A d d e n d u m

Iowa Department of Transportation
Office of Contracts

Date of Letting: March 18, 2014
Date of Addendum: February 26, 2014

B.O.	Proposal ID	Proposal Work Type	County	Project Number	Addendum
107	57-1001-079	PCC PAVEMENT – GRADE & REPLACE	LINN	NHSX-100-1(66)--3H-57 NHSX-100-1(79)--3H-57 NHSX-100-1(84)--3H-57	18MAR107.A01

PLAN VIEW OF PROPOSED DRILLED HOLE LOCATIONS ON EXISTING BRIDGE DECK

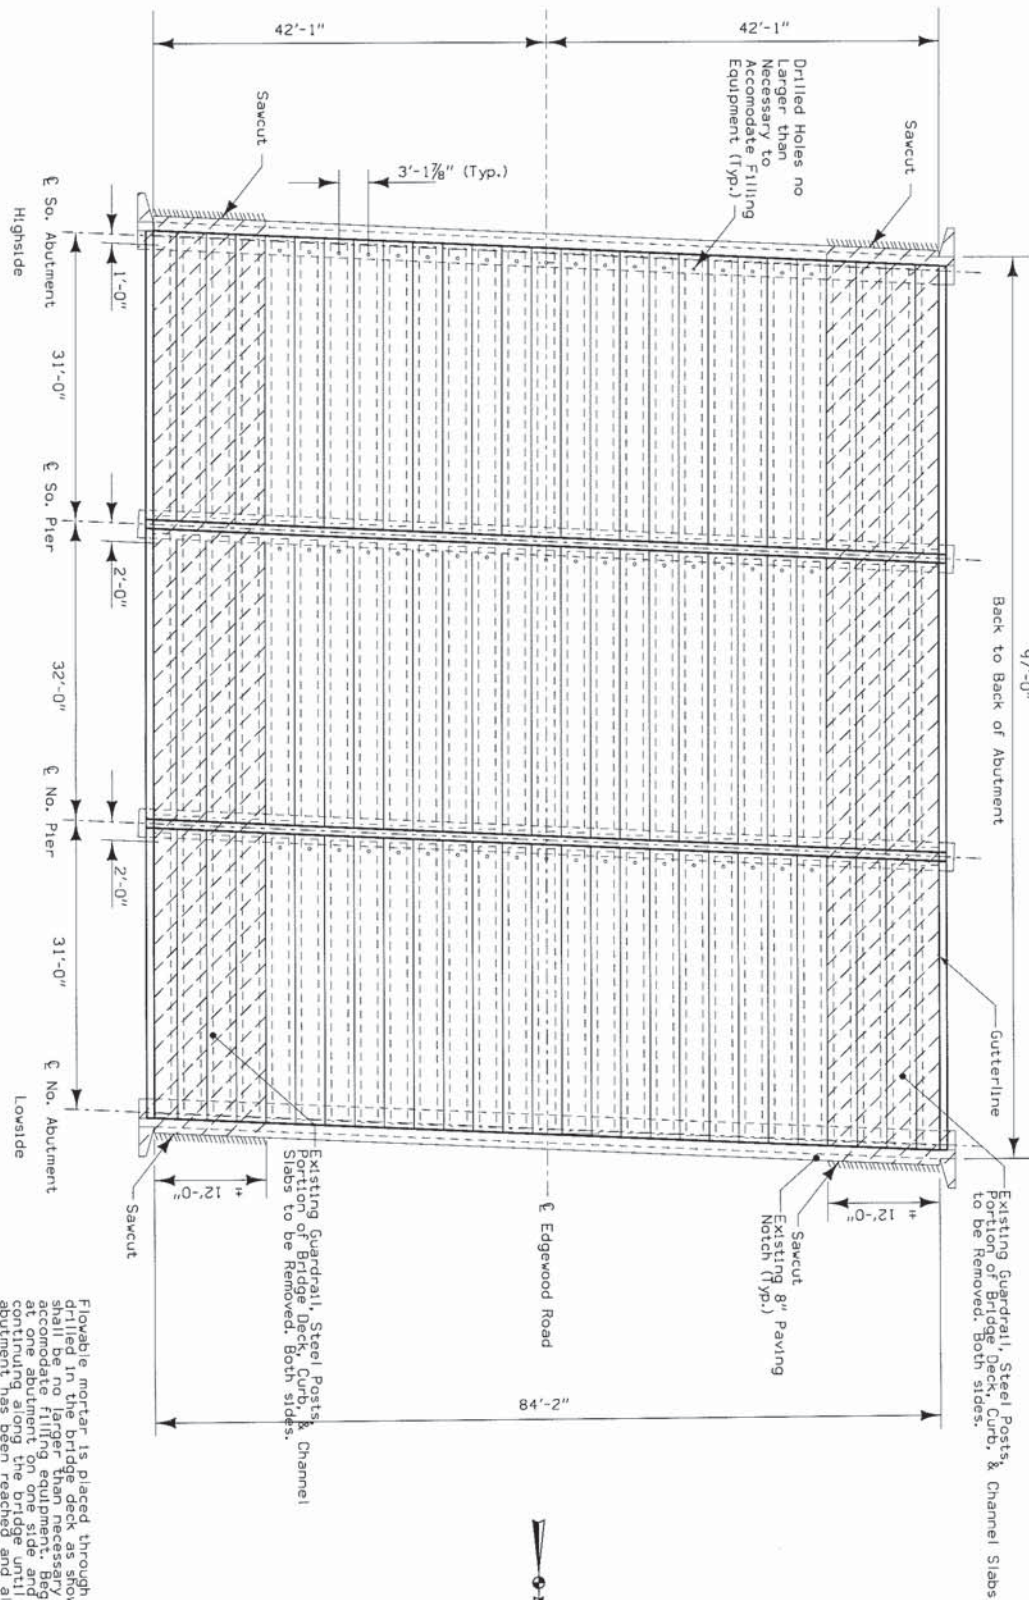
Attached is a plan sheet from an as-built plan set showing the details of abandoning the existing Edgewood Road Bridge as part of a previous City project. Plans estimated a total of 1,274 CY of flowable mortar. A portion of the original bridge was removed when it was abandoned. Per the as-builts there should be about 60' of deck width remaining and two pier substructures.

Flovable mortar is placed through holes drilled in the bridge deck as shown. Holes shall be no larger than necessary to accommodate filling equipment. Beginning at one abutment on one side and then other abutment as shown, fill and all of the holes filled on one side of the centerline. Then by beginning on the other side of the bridge and working the holes nearest the centerline and then the outer side, you can fill the holes on the other side. Mortars in the holes shall be removed and replaced with a suitable P.C.C. mixture. Drilled holes may be used as placement locations for flovable mortar or as weep holes.
